Re: Innovation Park – Subdivision Modification Request Memo

ATTACHMENT 1**Innovation Park – Tentative Subdivision Map****Proposed Subdivision Modification No. 1****Non-Standard Roadway Centerline Radius at Northwest Corner of Site****Description of the Modification:**

Proposed Subdivision Modification No. 2

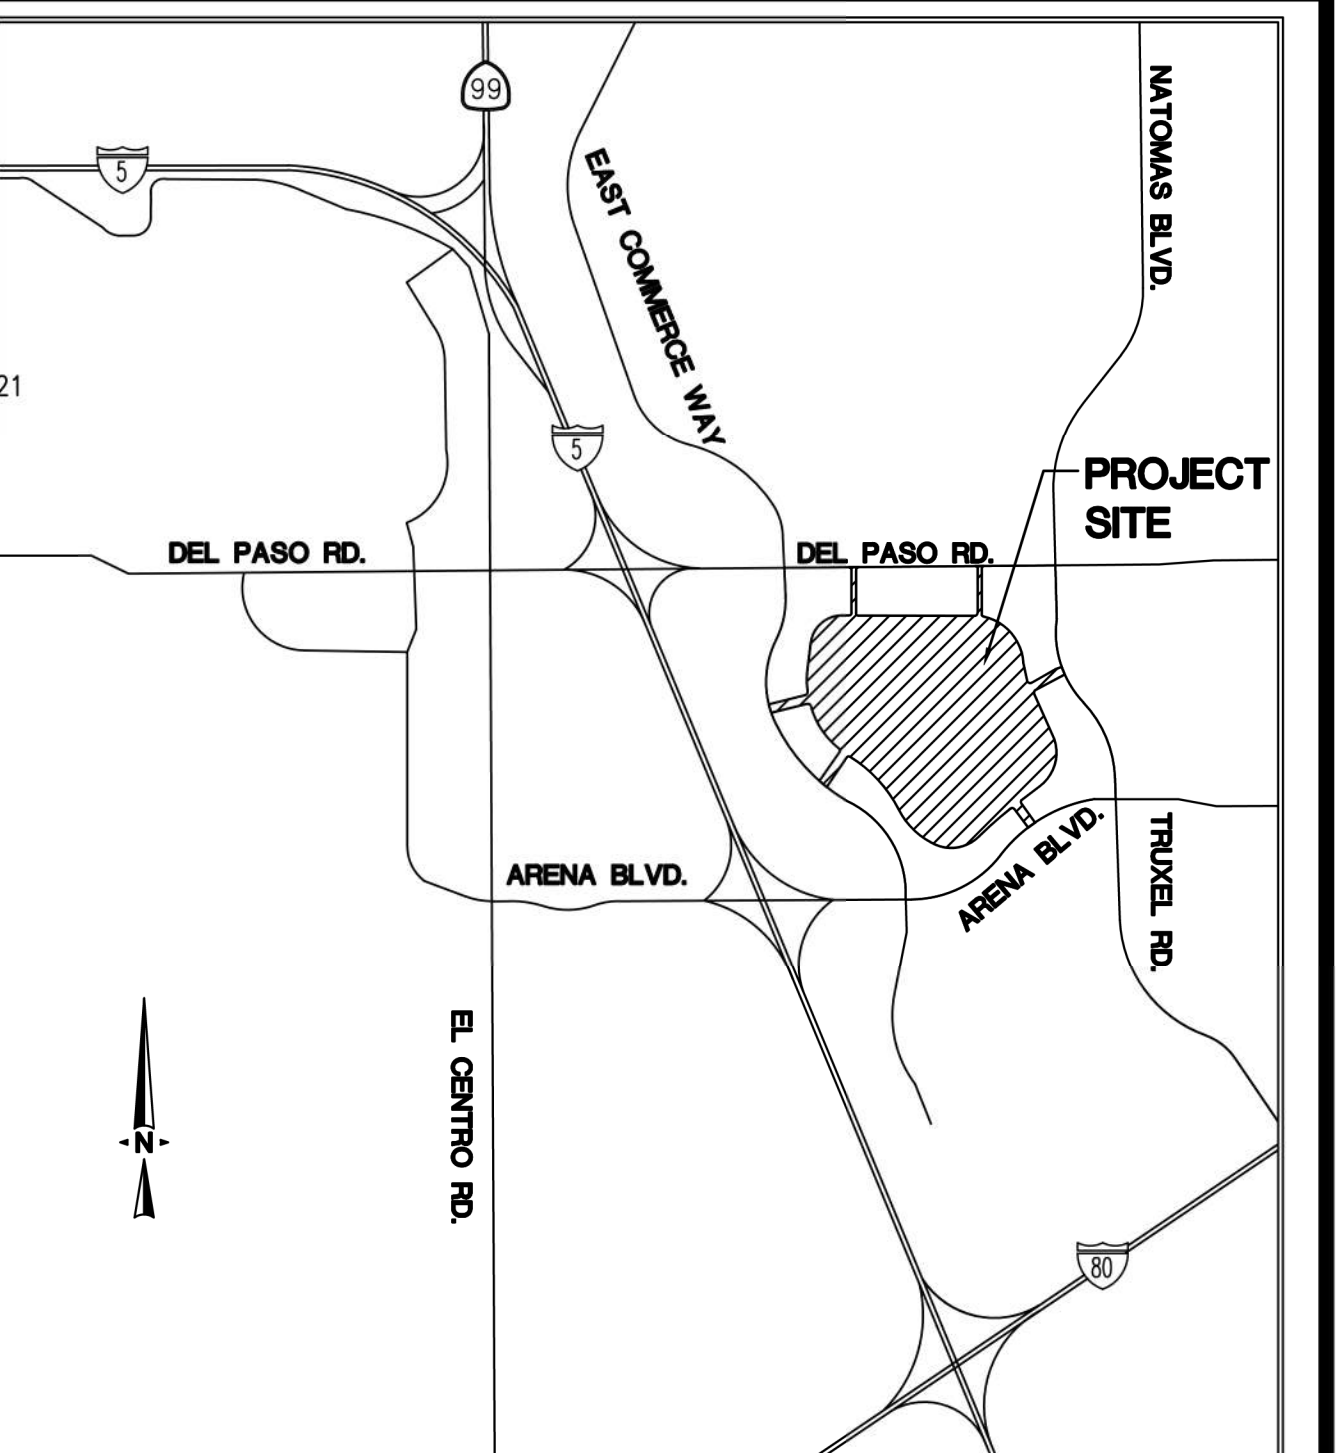
- REQUESTED SUBDIVISION MODIFICATIONS FOR:
 A. "D" STREET BETWEEN "D" STREET AND "A" STREET
 B. "C" STREET BETWEEN "E" STREET AND "B" STREET
- FUTURE ACCESS TO LOTS 6, 7, 26, AND 27 MAY AFFECT CONTINUITY OF LANDSCAPE LOTS "A" AND "F". SPECIAL TREATMENTS WILL BE PROVIDED AT FUTURE DRIVEWAY LOCATIONS INTERSECTING PROPOSED BIKE TRAIL.

INNOVATION PARK
CITY OF SACRAMENTO, CALIFORNIA
SUBDIVISION MODIFICATION EXHIBIT
NORTHWEST CORNER

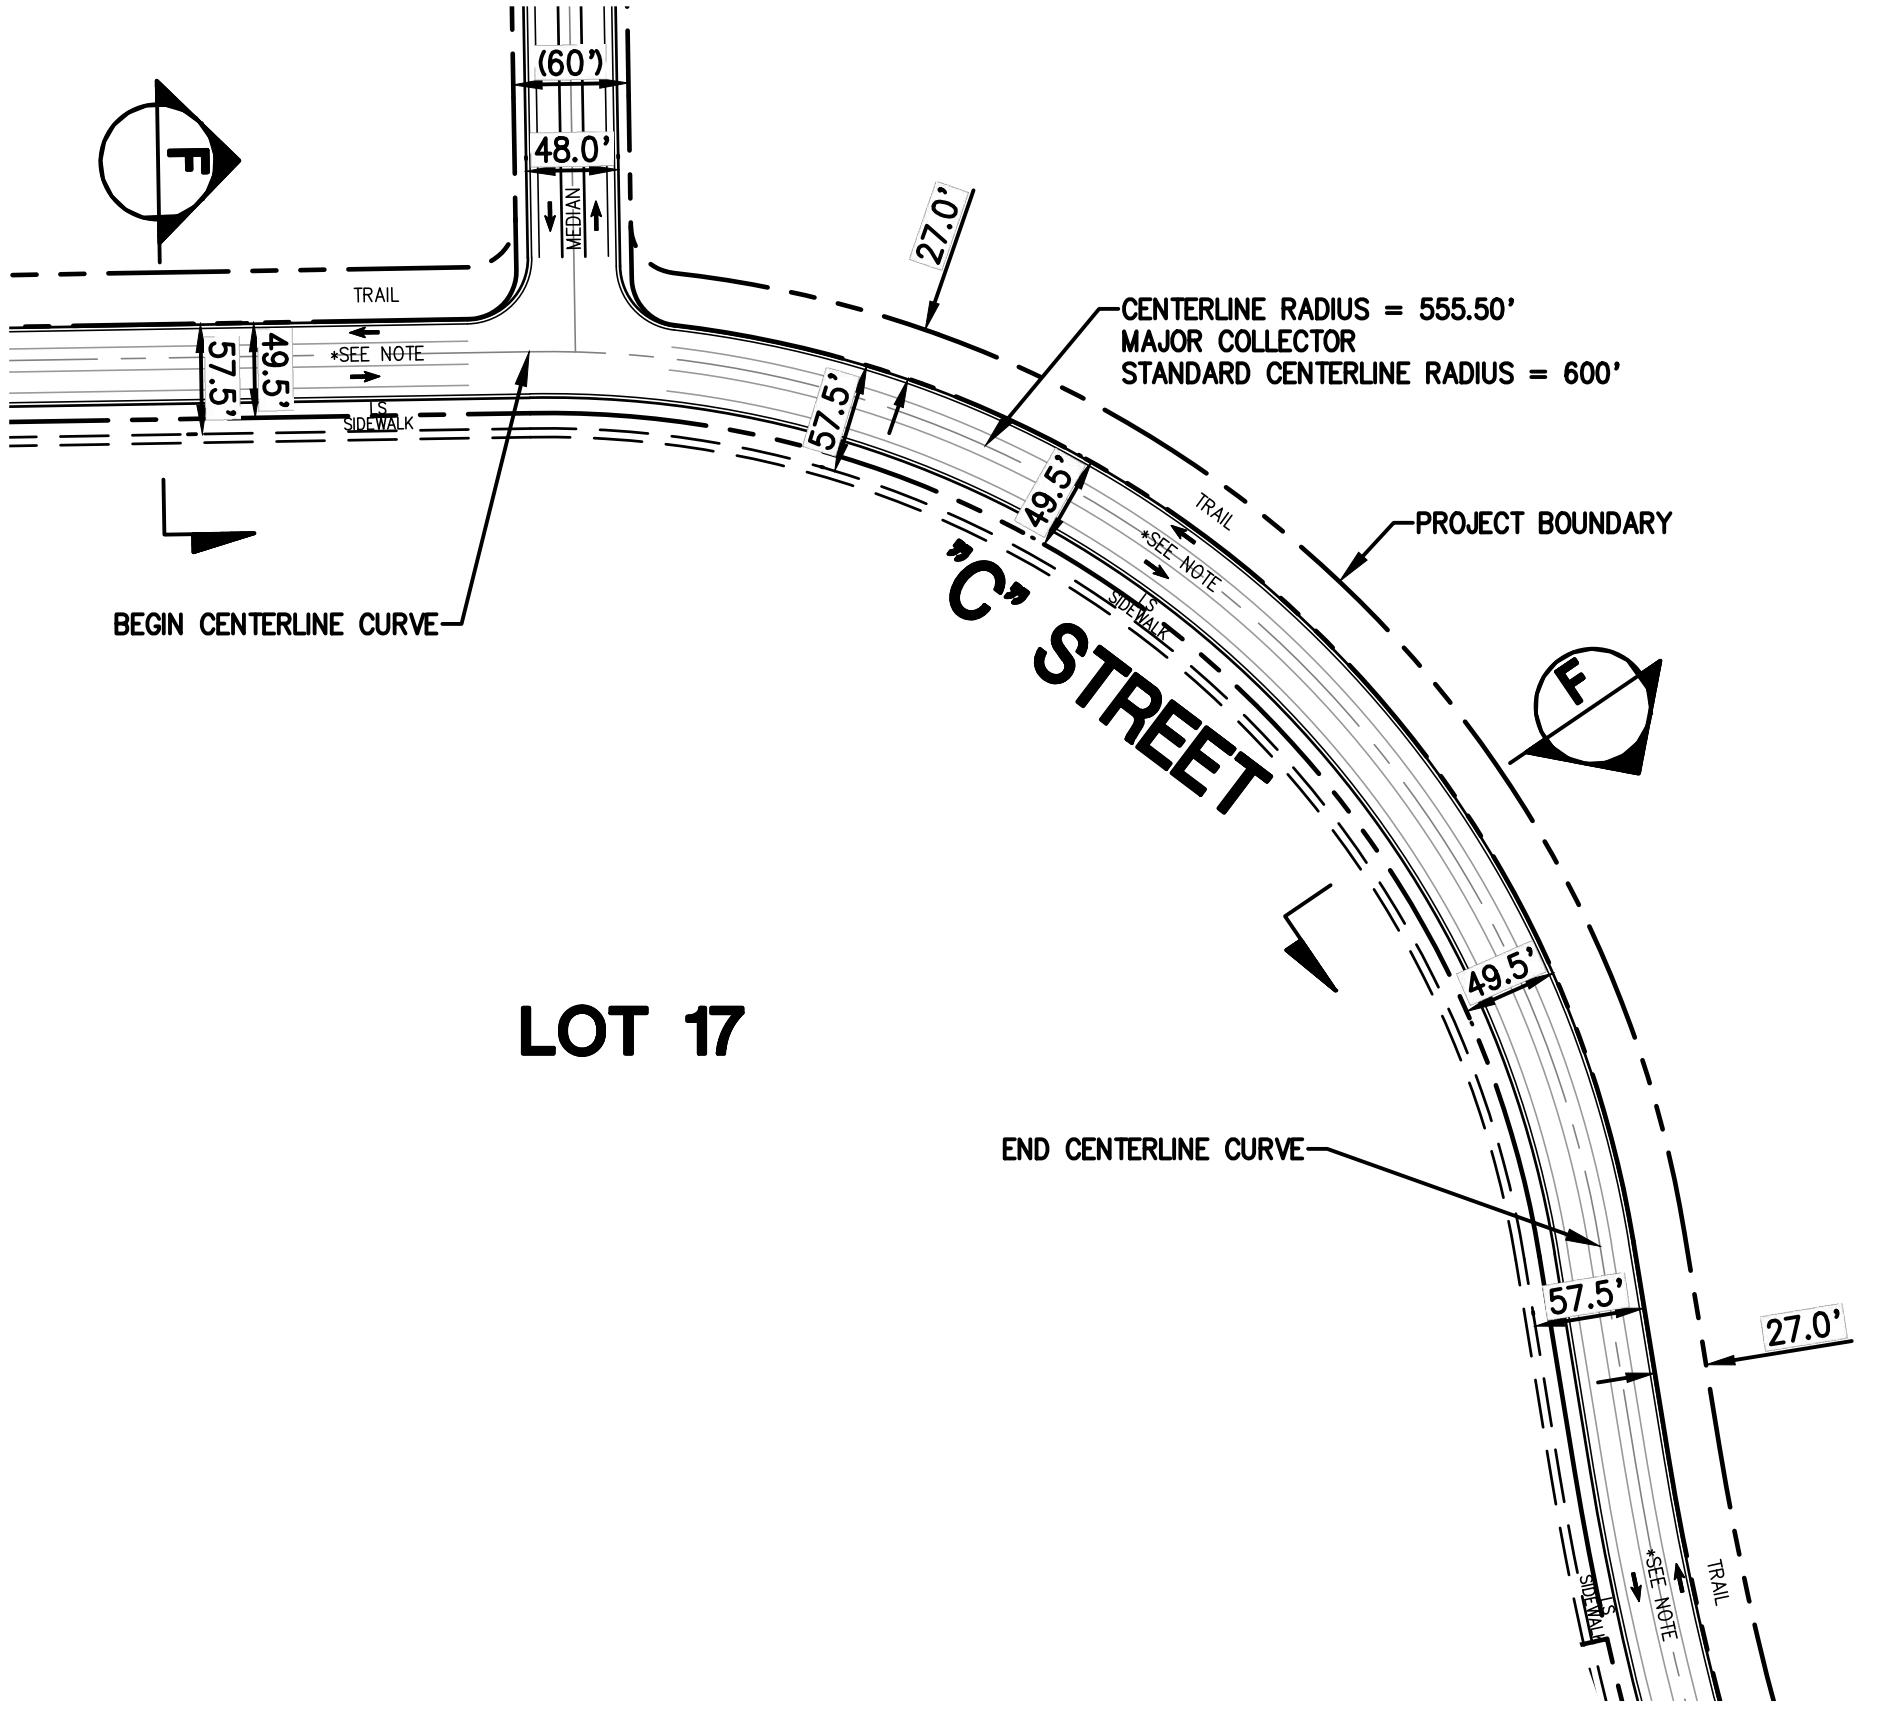
This modification request is to modify the minimum radius of Local Commercial Street from 400' to 355.50', to follow the existing project boundary at the northwest corner of C Street (near Lot 12).

- Roadway Classification and Geometry:
 - We are requesting a 44.5' centerline radius deviation from standard. The City Local Commercial Street standards require a 400' centerline radius. Due to geometry constraints, the proposed design will provide a 355.50' centerline radius.

- Our design seeks a minimum 100' tangent into the intersection, and this design provides approximately 120' before the intersection.
- Traffic Volumes

ACCESS CONTROL MEDIAN
(2' MIN) TO RESTRICT/
CONTROL ACCESS TO LOT 12
AROUND CURVE.
NO PARKING EITHER SIDE OF STREET
AROUND CURVE

CENTERLINE RADIUS = 355.50'
LOCAL COMMERCIAL
STANDARD CENTERLINE RADIUS = 400'

- Design Elements:
 - Per the tentative map section notes, as discussed and coordinated with Public Works, this section will be Local Commercial Standard City Plate 15-3, modified with no on-street parking adjacent to the proposed SMUD substation on Lot 12 with 2' access control median. See Attachment 3 for the pertinent roadway section (Section E on the Tentative Subdivision Map).

- The exact median geometry, striping and signage will be finalized at final design to the satisfaction of Public Works and the Fire Department.

SECTION E

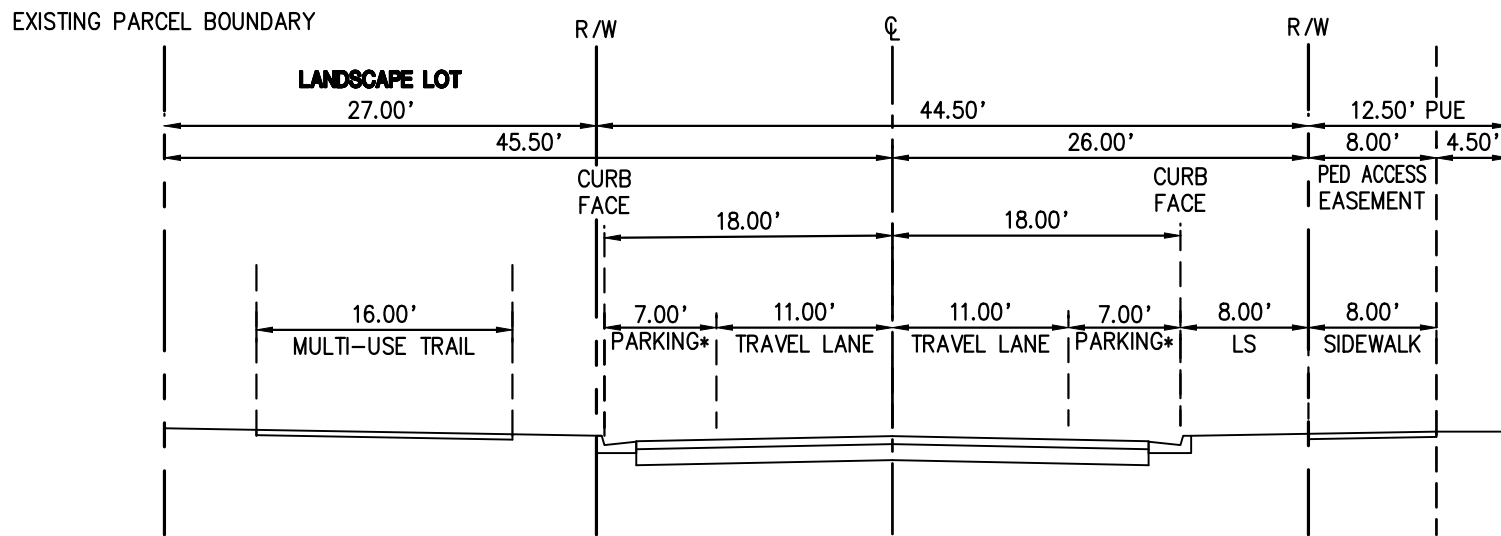
NOTE: ROADWAY TO BE LOCAL COMMERCIAL PER CITY PLATE 15-3.

*NO PARKING ADJACENT TO PROPOSED SMUD FACILITY (LOT 12) WITH 2' ACCESS CONTROL MEDIAN

SECTION F

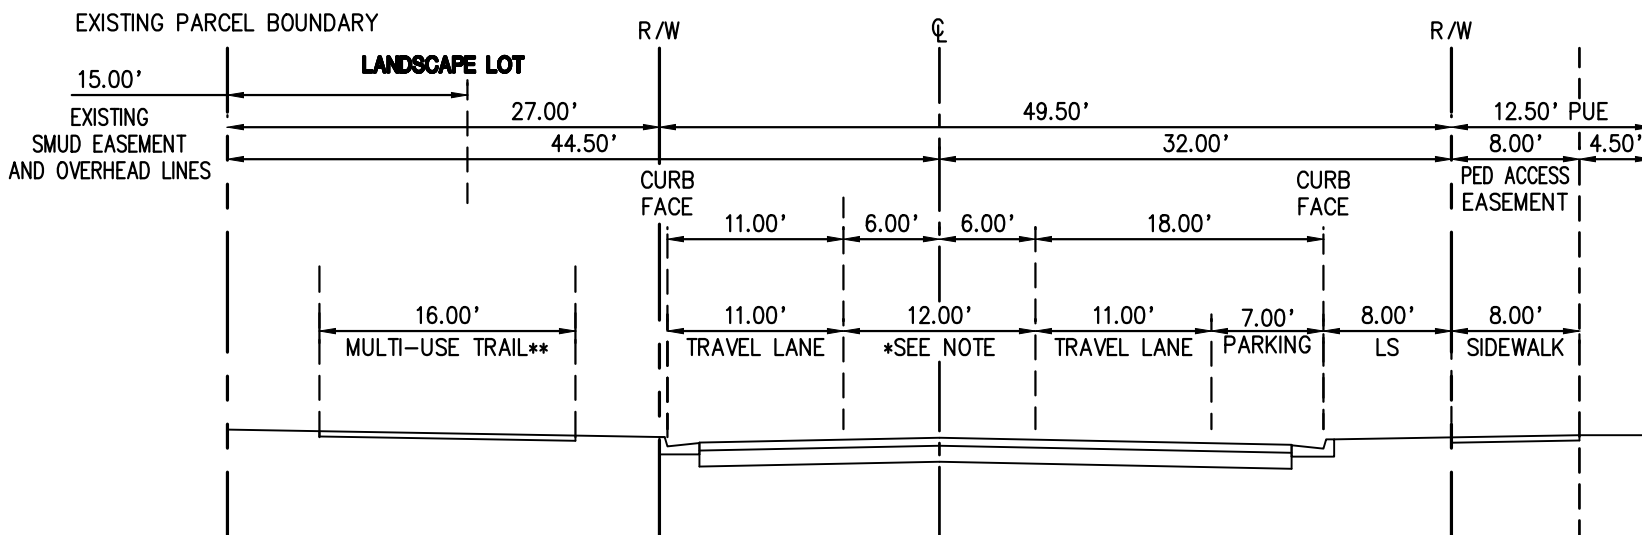
*NOTE: TWO WAY LEFT TURN LANE, 2' ACCESS CONTROL MEDIAN, OR LEFT TURN POCKET WITH NO ON-STREET PARKING

**CLEARANCE SHALL BE PROVIDED TO EXISTING SMUD POWER POLES TO THE SATISFACTION OF SMUD AND PUBLIC WORKS.
